Project Name: Village of North Palm Beach Wash Down Metal Building
Palm Beach, FL 33480

ADDENDUM NO. 1

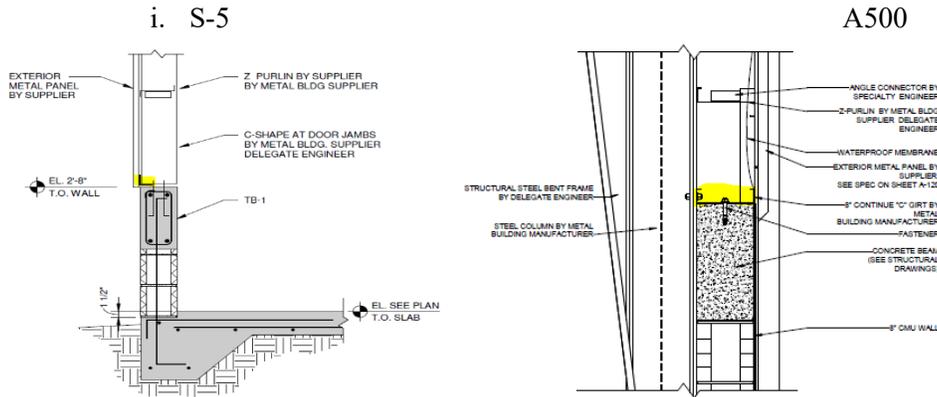
3. Collateral loads of 5 for substrate, 5 for insulation and 5psf for mechanical are unusually high. If the substrate requirement is removed 5psf is normally enough for lighting, light mechanical, sprinkler systems point loads, and the thin insulation specified. Will a 5psf collateral be acceptable?

Where roofing is to be the structural roof deck, one material for both purposes, the 5 psf for roofing could be omitted.

MEP/MISC shall remain at 5 psf to allow room for possible future design changes.

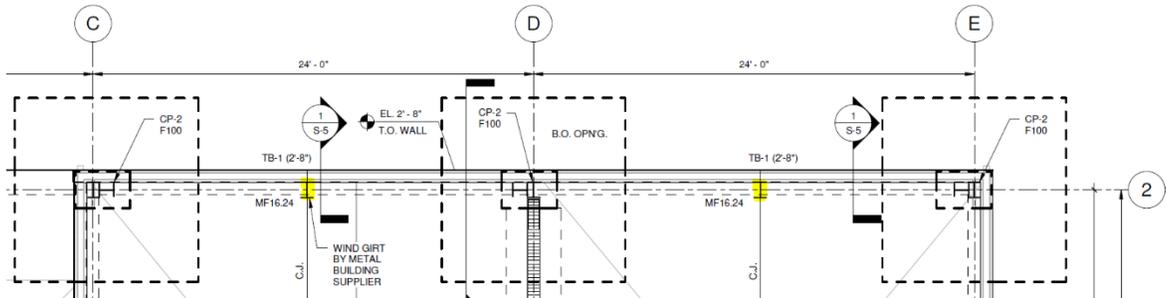
28. What is the purpose of the columns along line 2 at midpoint between frames C&D and D&E on S1 and S2?

These are vertical wind girts for exterior wall purlin support (TJF/ONMJ).
